DRAWING AMENDMENTS

Serialno: 09/441, 537
Replacement Sheet

FIG. 1 (Prior Art)

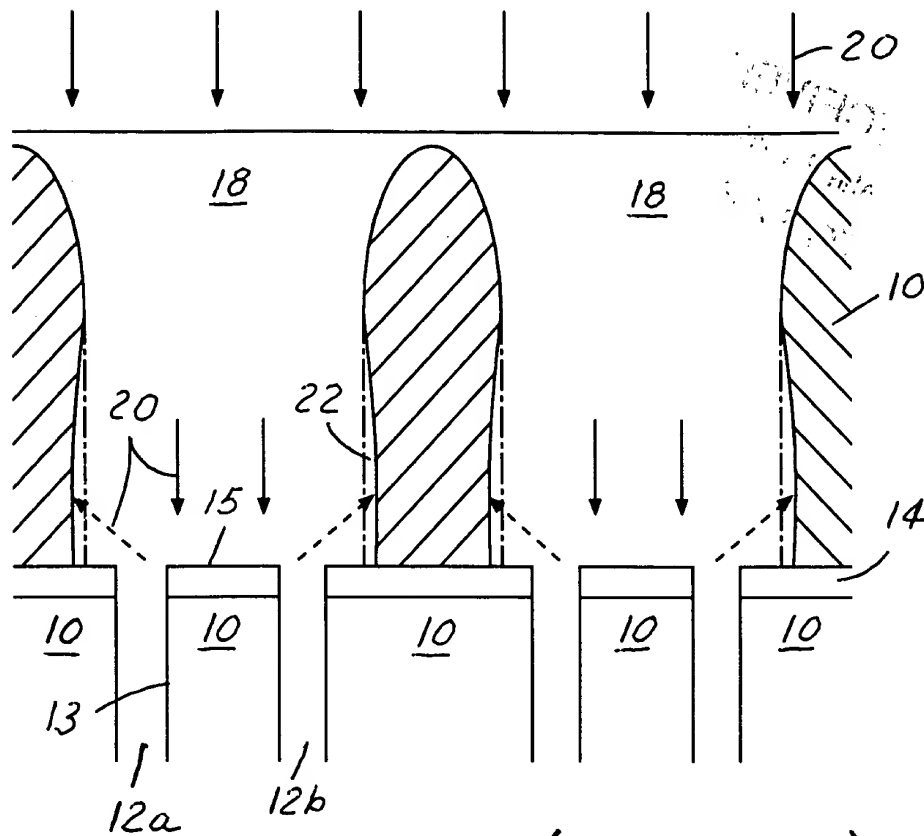
The drawings have been amended to address Examiners noted errors. In Figure 1, a 'prior art designation has been added and the resist layer renumbered 16. In Figure 3, the trench opening has been renumbered 39 and the resist layer has been renumbered as 37 to avoid redundant numbering. The First ARC layer has been shown and designated as 36 to be consistent with the Specification and consistent with the structure and designation number 26 shown in Figure 2.
